File No. 111039. A substitute ordinance relating to the change in zoning from Local Business to Detailed Planned Development, for residential development, on lands located on the northwest corner of North Jackson Street and East Pleasant Street, in the 3rd Aldermanic District. This zoning change was applied for by Dermond Property Investments, and will allow for the construction of a five-story, 36-unit residential building.

## 1601 Jackson Apartments

Changes since previous CPC recommended approval on 01/09/2011:

# 1601 Jackson Apartments Proposed Landscape Plan

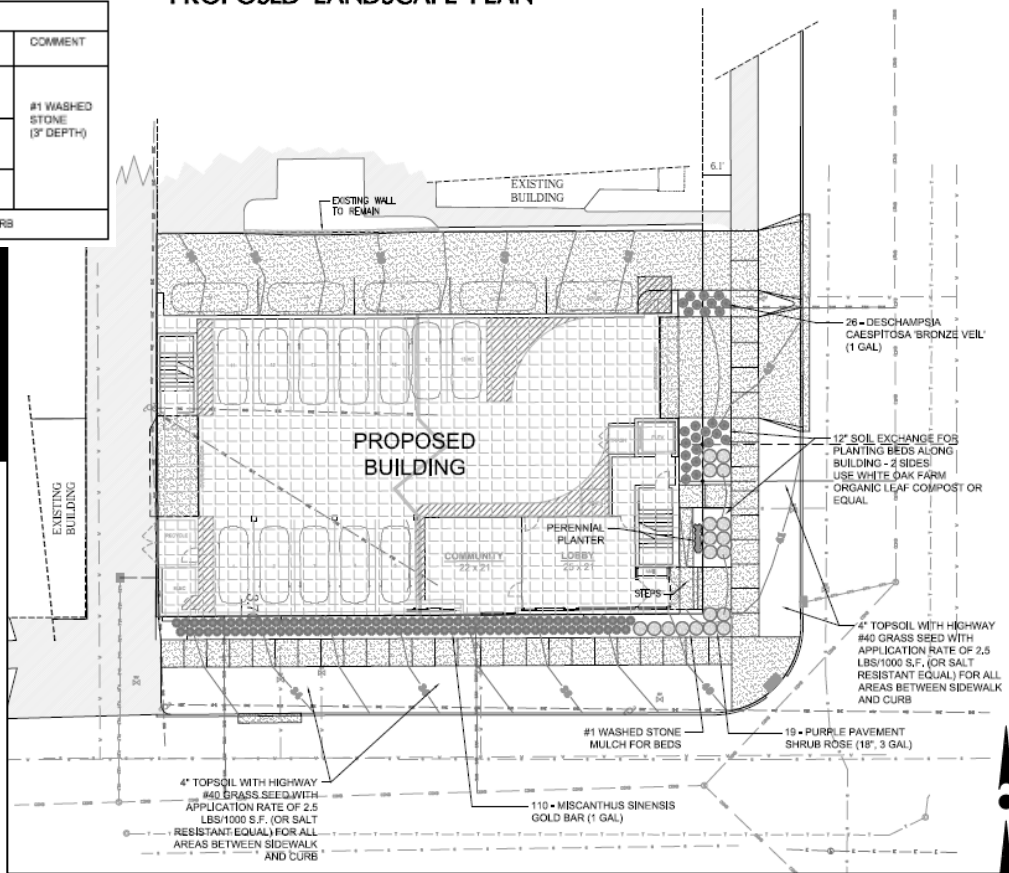
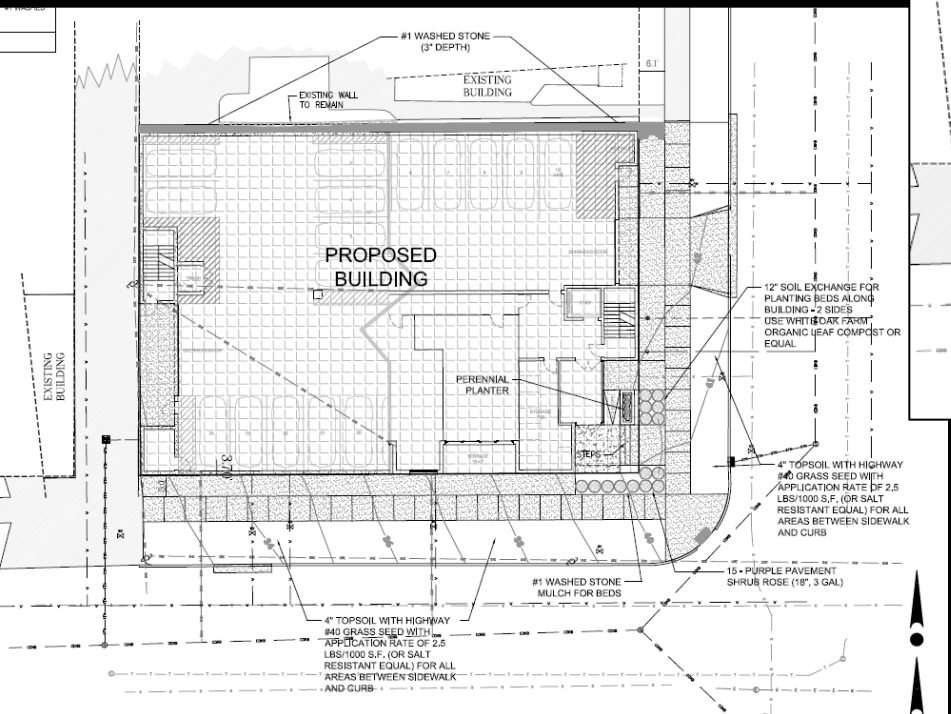
Above: Proposed Landscape Plan

Below: Previously Approved Landscape Plan
